FERN AVENUE  
Long Island

97-1-1,2,7,8

AP - Fern Avenue, Long Island  
City of Portland Public School New Basement Entrance

Subject: Some questions about framing of proposed  
school at Long Island

Dining Rm. To be Torn down And Rebuilt \*

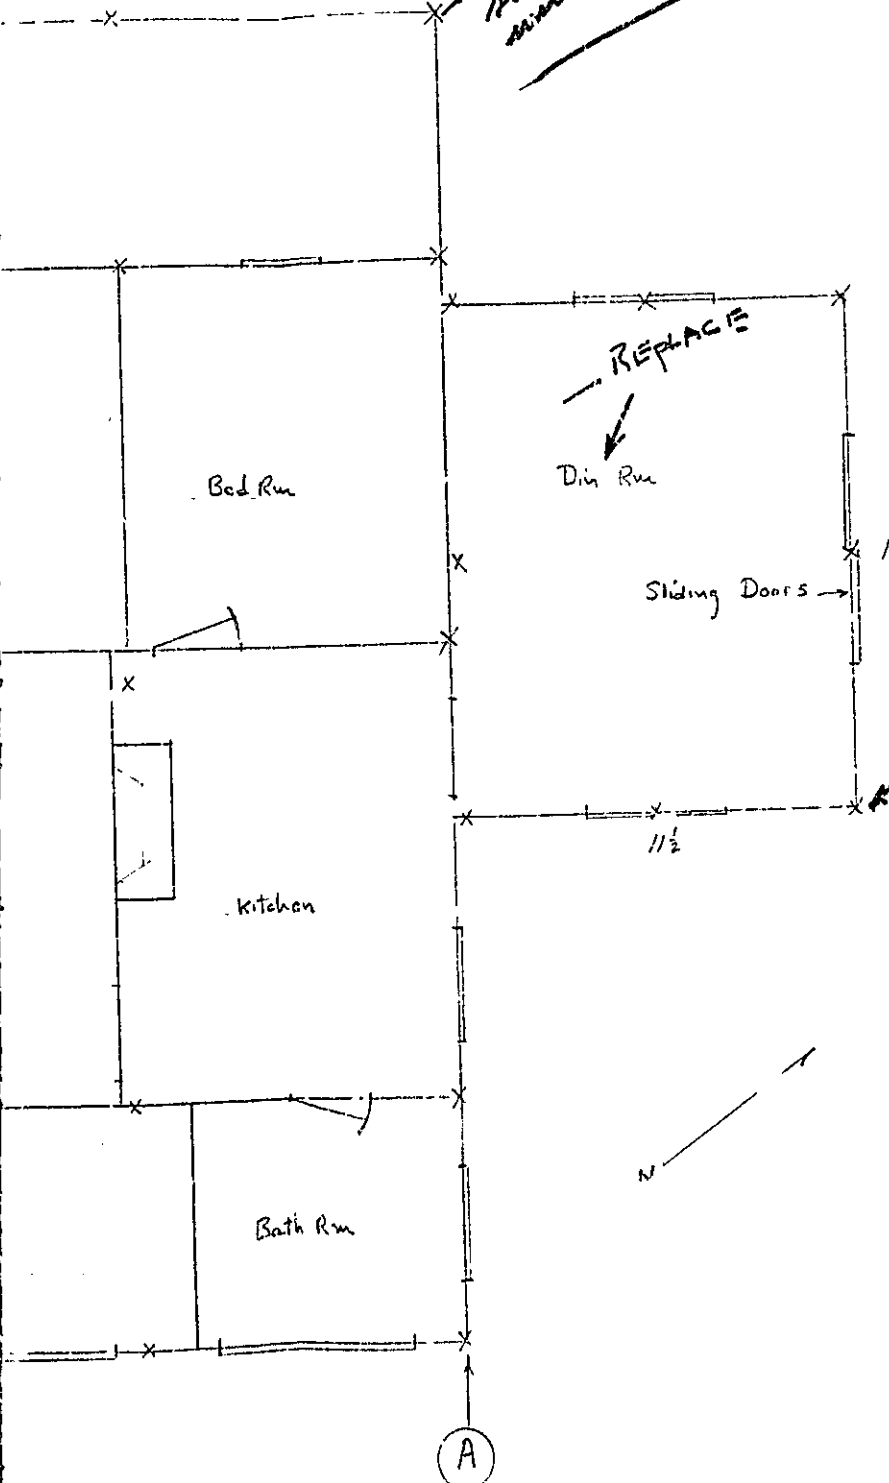
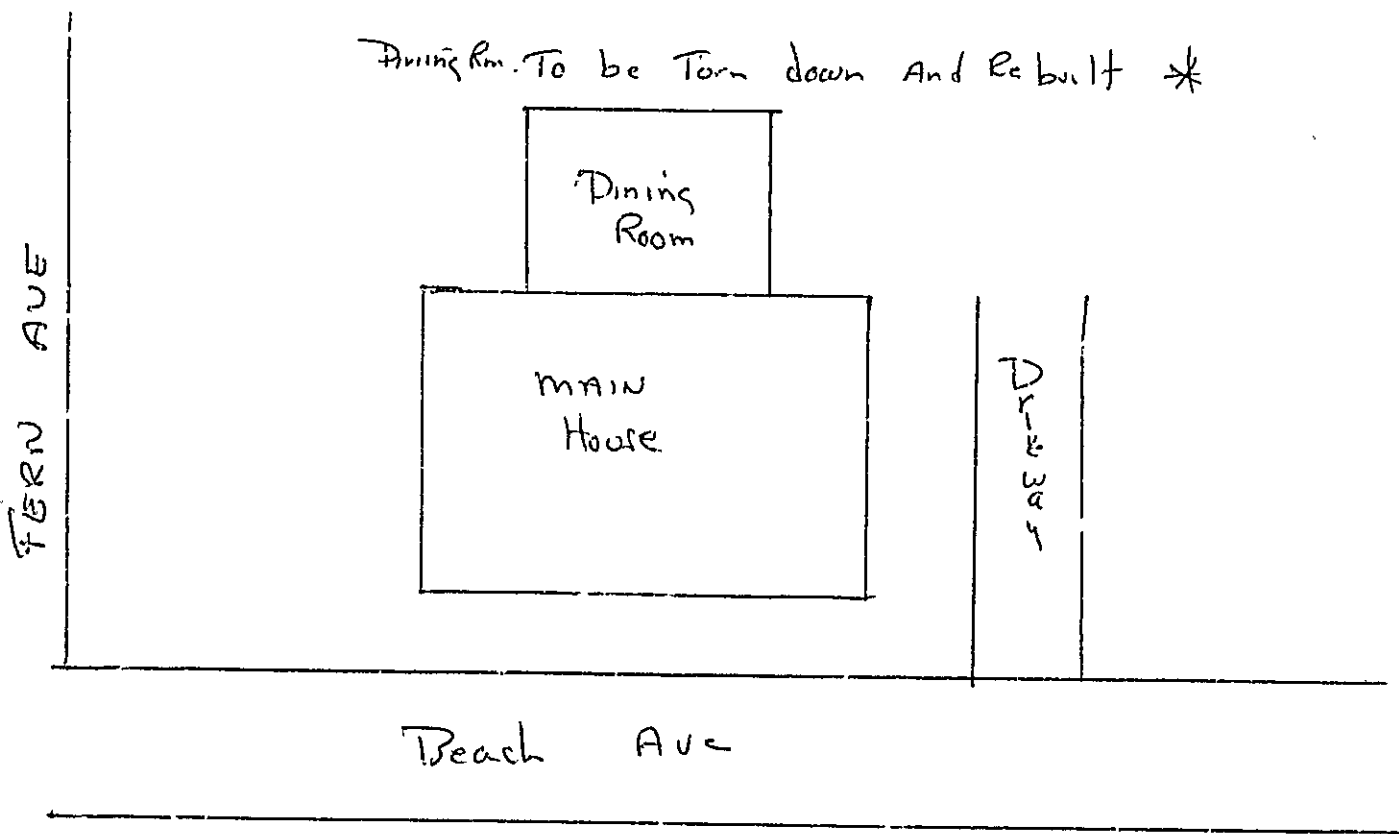
We intend to replace wooden posts marked "X" on Line A with concrete posts, sunk below the frost line. Where original 2x6 carrying timbers have deteriorated, we intend to replace with 2x8, doubled. 2x4 floor joists will be replaced with 2x4.

We intend to rebuild the Dining Room, on the original floor plan. This room will be built on a box foundation of 2x8 on 16" centers. The double pitched roof will have 2x6 rafters on 16" centers. Flooring, siding and roof will be  $\frac{1}{2}$ " plywood.

In your letter received this date, please be advised that your contractor is required to make application at this office to do the work outlined in your letter.

No work is to be started on the property until your contractor has applied at this office for a permit.

SCHOOL BUILDING

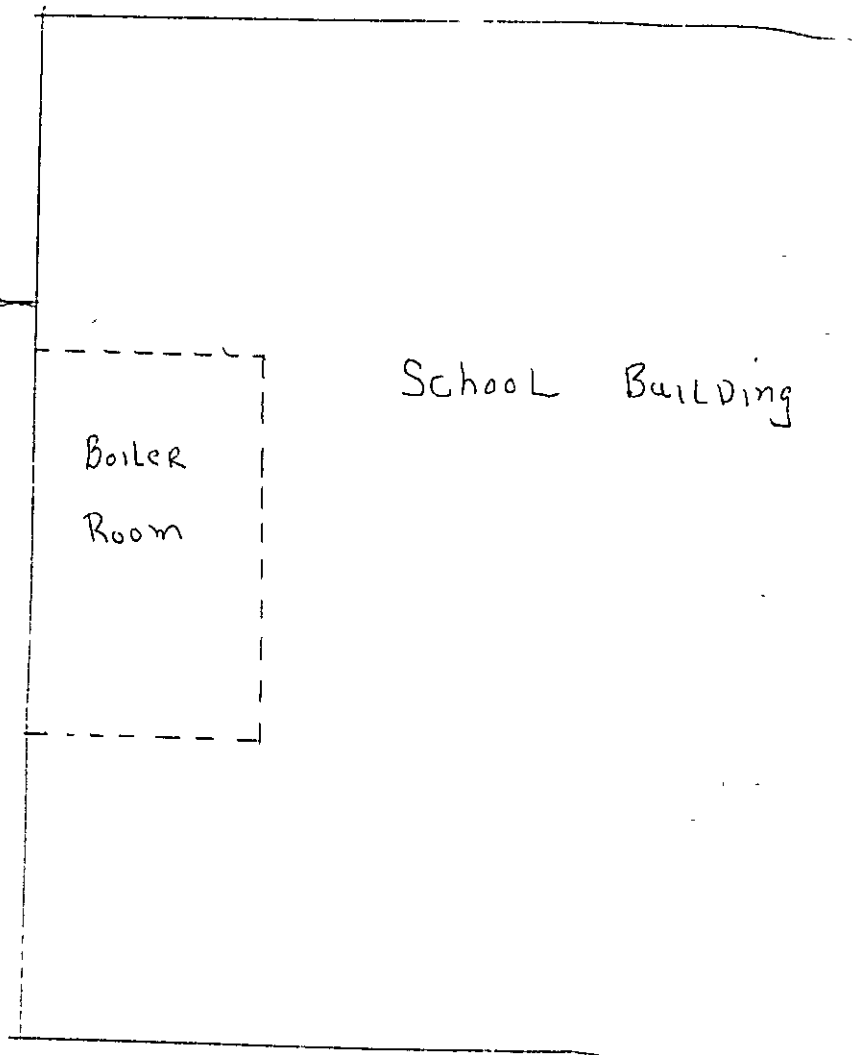
2000 GAL. TANK  
TOP OF TANK 3'0"  
BELOW SURFACE

This application for a tank installation at the Long Island School is approved by this office providing that the tank is suitably anchored if water is encountered in the tank opening.

The Fire Department is to be notified before burying for possible inspection. The tank is to be labeled and of #7 gauge.
